Final
Initial Study / Mitigated Negative Declaration
SCH No. 2022100635

CONWAY RESIDENTIAL SUBDIVISION
PL21-0269

Table of Contents

Figure 2a – Proximity of project line to active vineyard on 2166 Weiss Way

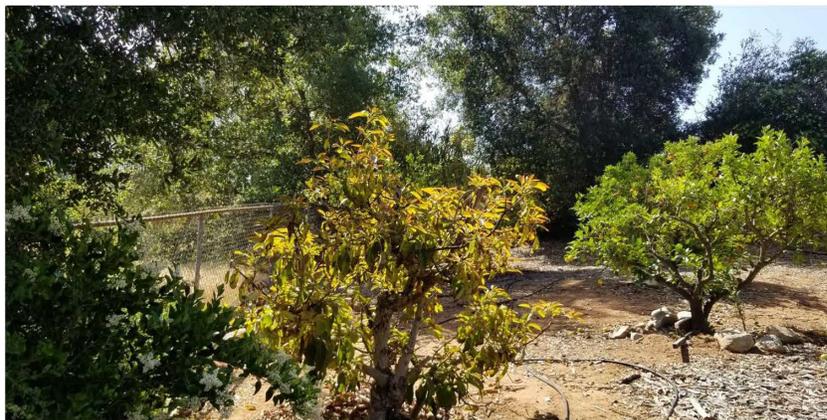
- 1.2 **Dust and air quality** – we expect that the grading will generate a significant amount of dust, particulate matter and debris that will drift onto our property. We don't know the potential chemical constituents of the grading detritus that could cause harm to our property and our respiratory health. We also have serious concerns about dust, flying debris and exhaust from the grading and construction equipment and how this will affect our active vineyard - and other producing fruit trees – both of which are literally feet from the property line. See Figure 2. In addition, we have a pool beyond the vineyard, and dust and debris will impact our pool, including the filter and motors, and all outdoor areas.

- 1.3 **Vegetation that transverses the 2166 Weiss Way property line chain link fence.** There is vegetation – trees and bushes - on both sides of the fence that demarks the property line between our property and the development. If the plan is for all vegetation in the project to be demolished, this will cause significant damage to the existing fence, as well as damage to the vegetation we have planted along our side of the property. See Figure 3. Is a fence proposed for the western side of the development along our property line? Will any existing trees or shrubs not be disturbed?

Figure 1 Impacts to Protected and Mature Trees

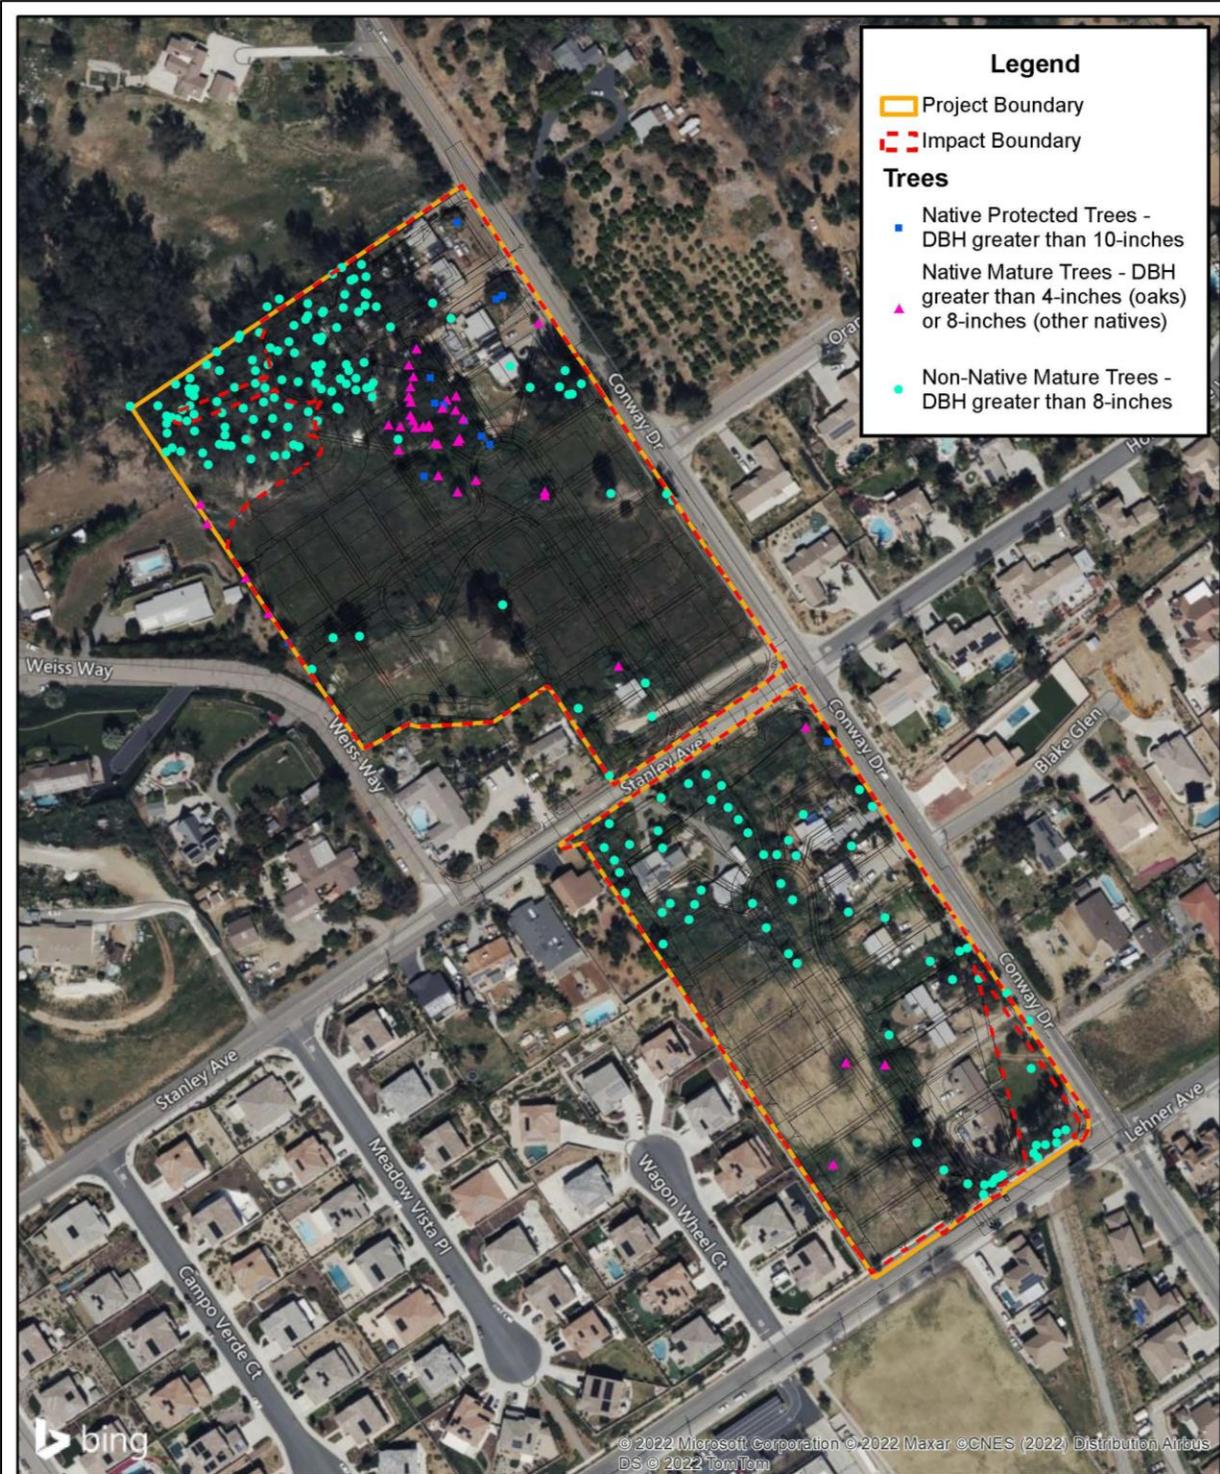
- O1-22 The comment suggests the MND did not provide information on impacts to mature and or protected trees. The *Biological Technical Report (BTR) for the Tract F and H Project* prepared by Carlson Strategic Land Solutions dated September 2022 and included in Appendix B to the Draft IS/MND includes an analysis of the tree survey and outlines impacts to mature and protected trees in Section 5.3 on Page 21. Appendix D to the BTR includes discussions and a multi-page spreadsheet identifying every tree on the Project site and whether impacts would occur. Attachment A: Figure 1 to the Final IS/MND and Figure 11 of the BTR graphically shows the locations of impacted trees.
